CRITICALITY SAFETY ANALYSES
FOR THREE MILE ISLAND UNIT 1
FUEL STORAGE FACILITIES

GPU NUCLEAR

Operating License No. DPR-50
Docket No. 50-289
Technical Specification Change Request No. 180

I. Technical Specification Change Request (TSCR) No. 180

Figure 1 New-Fuel Storage Vault Arrangement

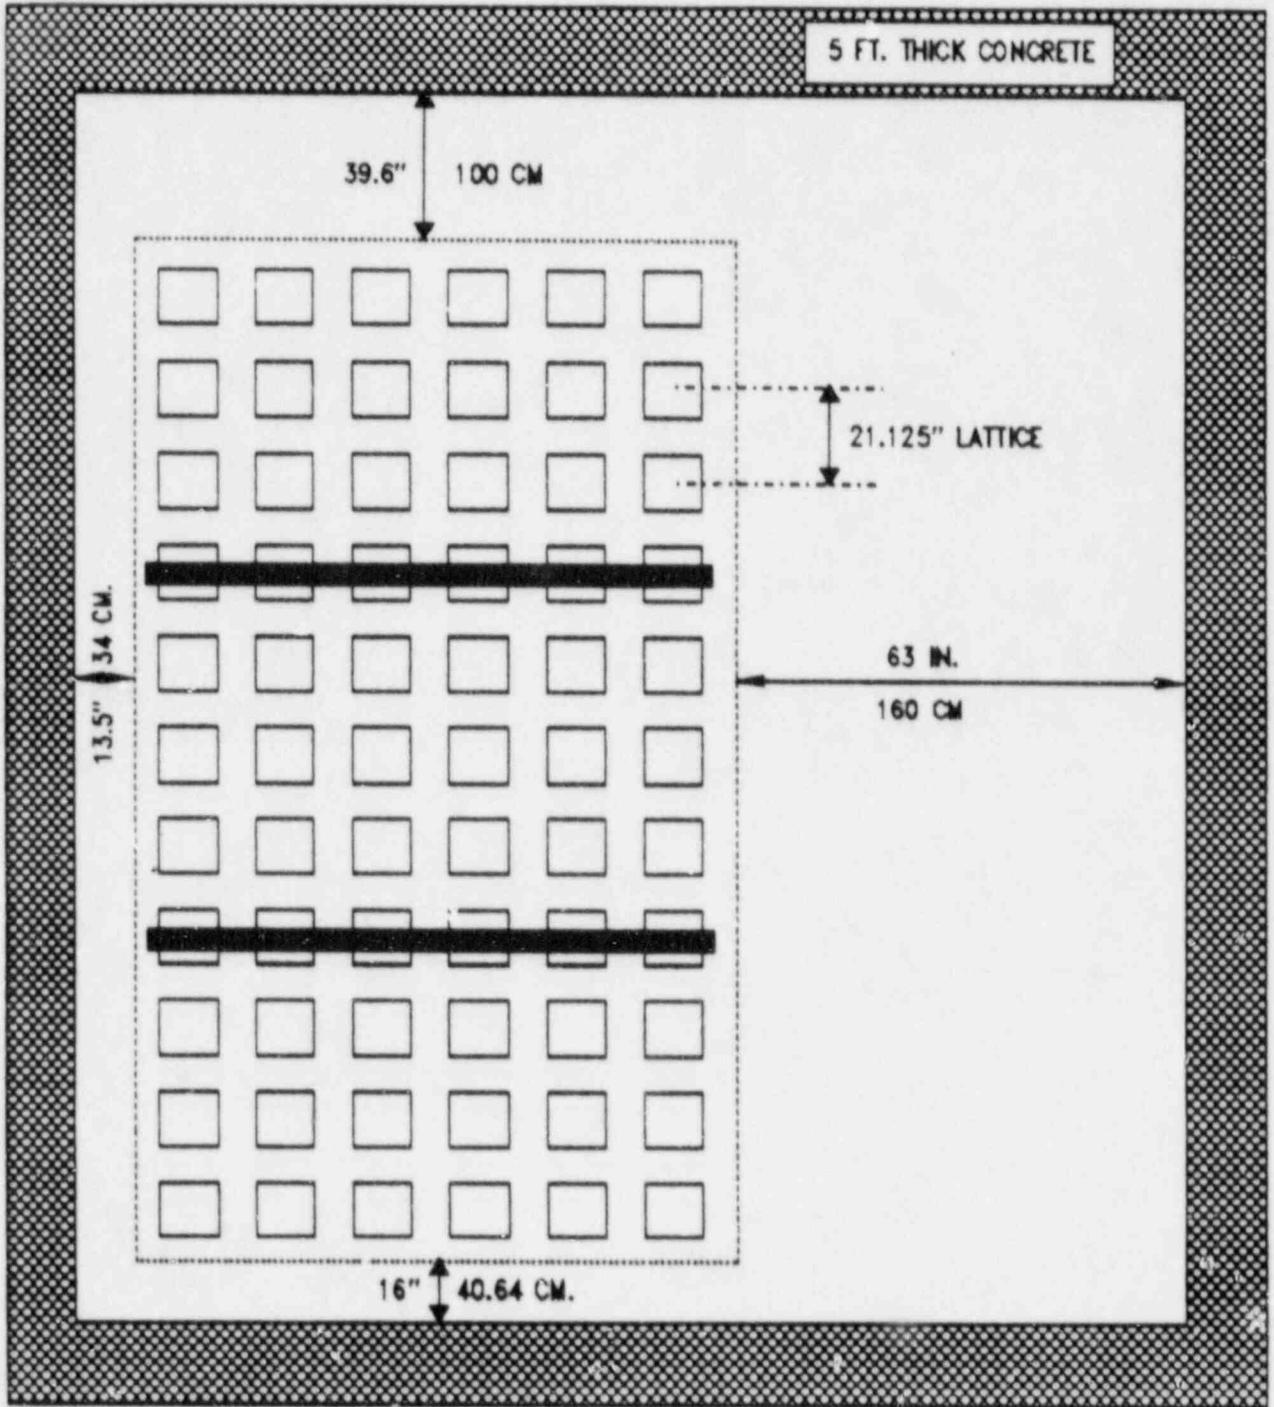
Calculations of the new fuel storage vault under low moderator density conditions were made using the configuration shown in Figure 1 and assuming that 12 storage locations in two rows were vacant. These 12 vacant locations, indicated on Figure 1 as black bars, provide additional leakage that is necessary for

the storage vault to satisfy SRP 9.1.1 requirements under low moderator density conditions. Figure 2 shows the calculated k-effective values for various moderator densities and indicates that the optimum moderation (maximum k-effective) occurs at a water density of -7.5%, with a maximum k-effective of 0.928 for 4.3% enriched fuel (with a one-sided tolerance factor '7' for 95% probability at the 95% confidence level).

1. The restriction to leave twelve (12) storage locations in the New Fuel Storage Vault vacant (aligned in two rows of six locations each; transverse rows numbers four and eight) of fissile or moderating material. The restriction will ensure that the NRC Standard Review Plan (NUREG 0800) Section 9.1.1 requirements for reactivity under hypothetical conditions of low density "optimum" moderation are met by allowing for the necessary additional neutron leakage.

Technical Specification Section 5.4.2(d) is being revised to add a note indicating that, of the 66 storage locations in the new fuel vault racks, twelve (12) of the locations are required to be vacant of fissile or moderating material.
